609 CS-01 Before

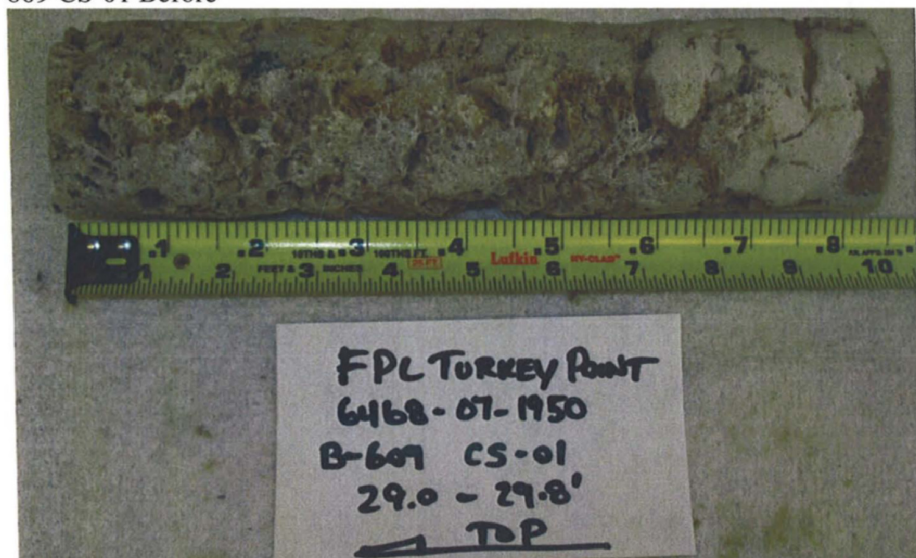
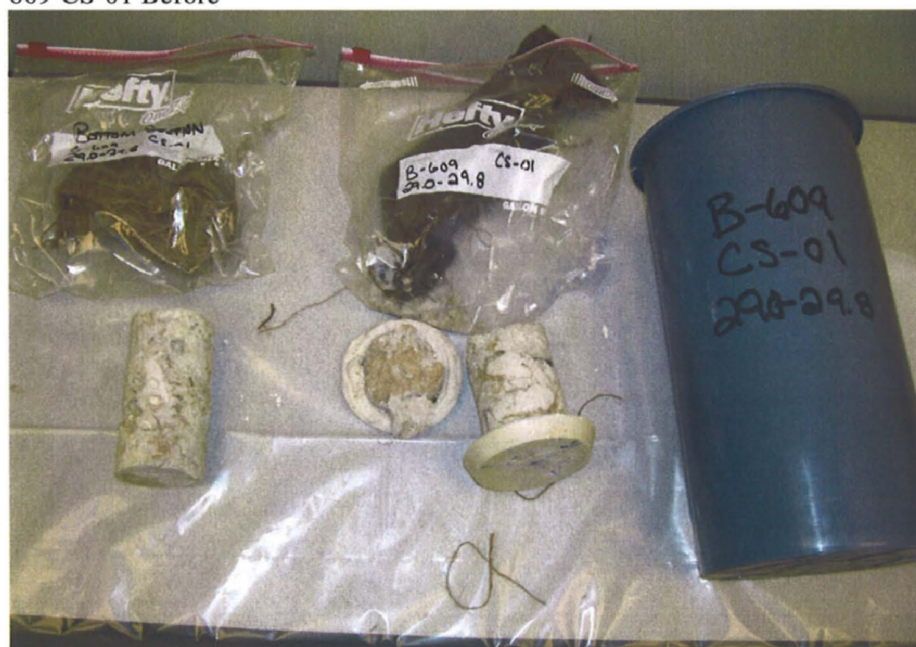
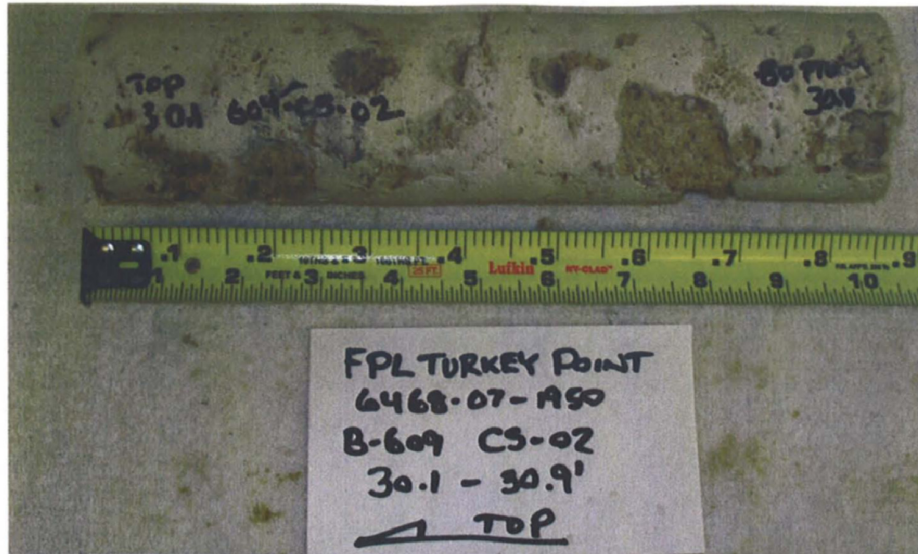
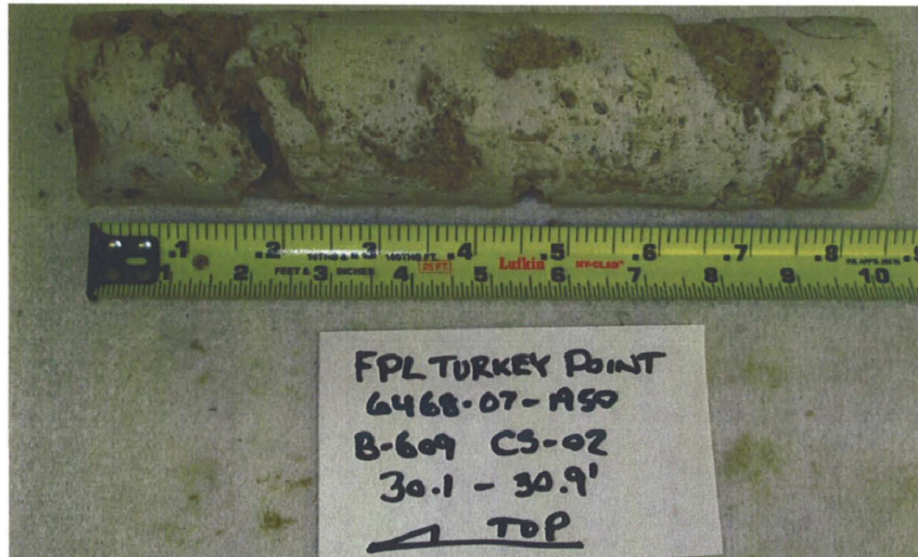
609 CS-01 Before

609 CS-01 After

609 CS-02 Before

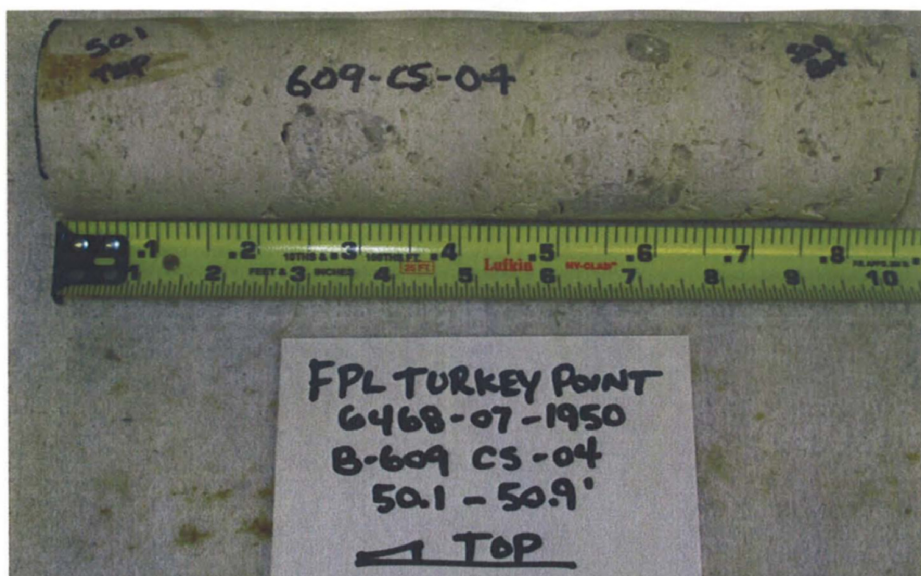
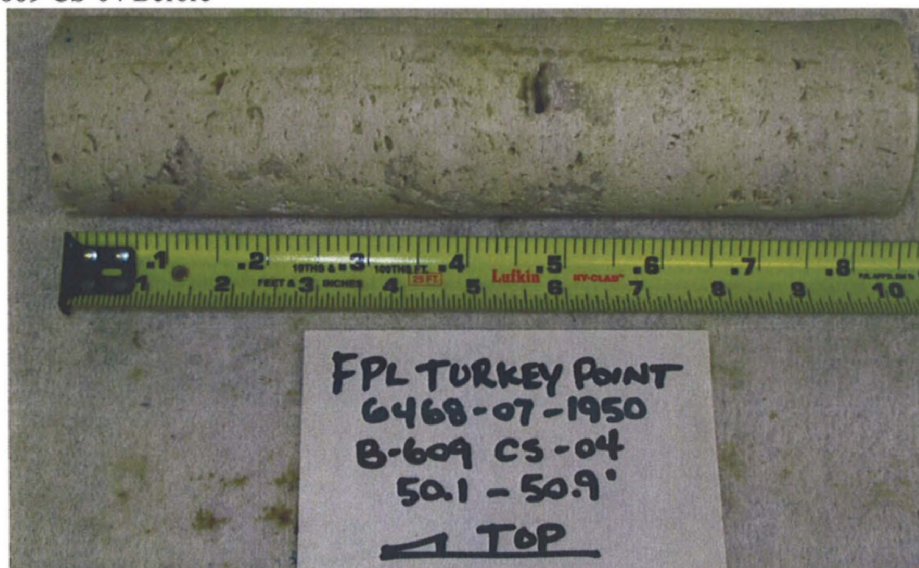
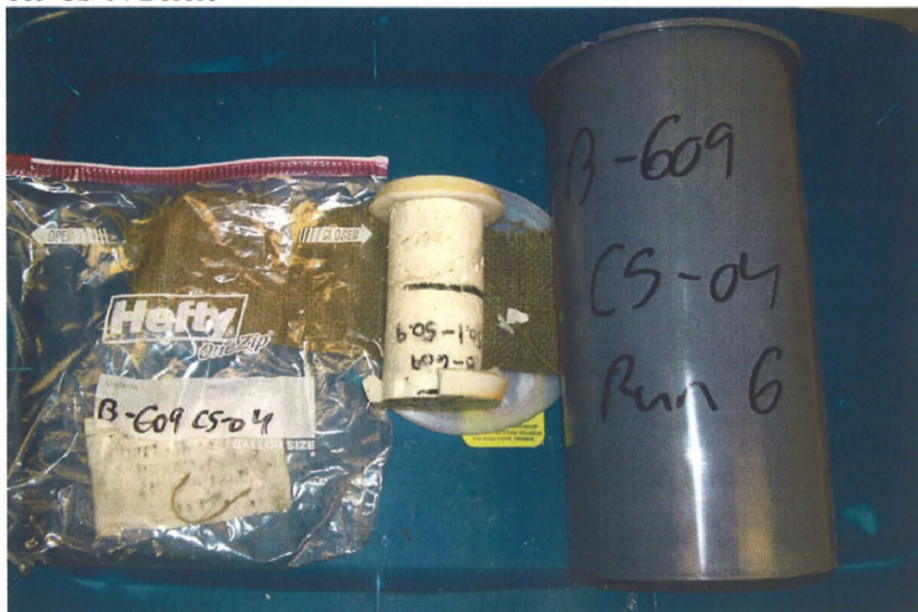
609 CS-02 Before

609 CS-02 After

609 CS-04 Before

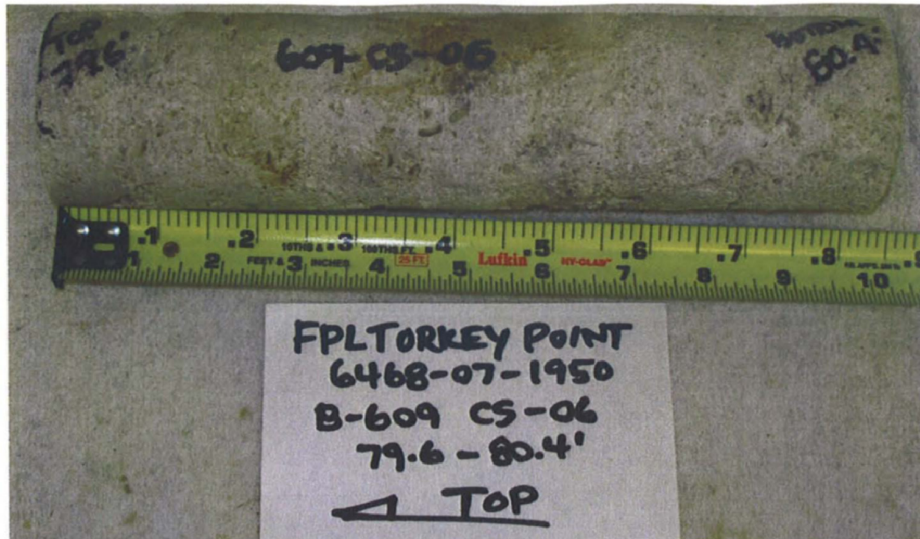
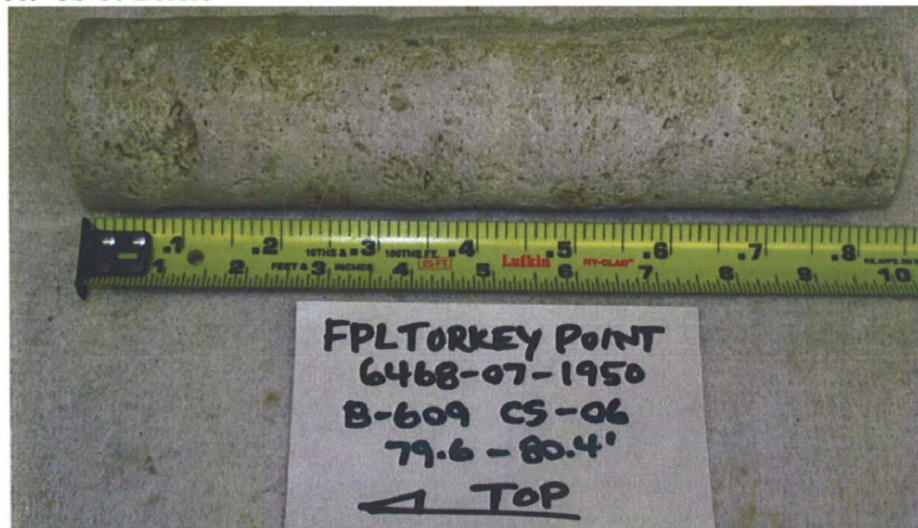
609 CS-04 Before

609 CS-04 After

609 CS-06 Before

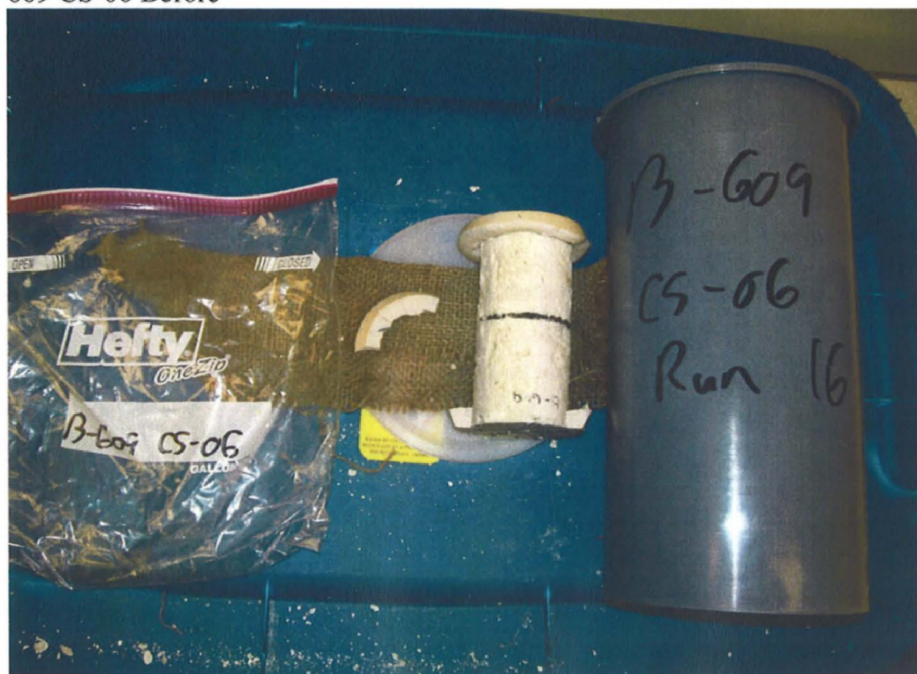
609 CS-06 Before

609 CS-06 After
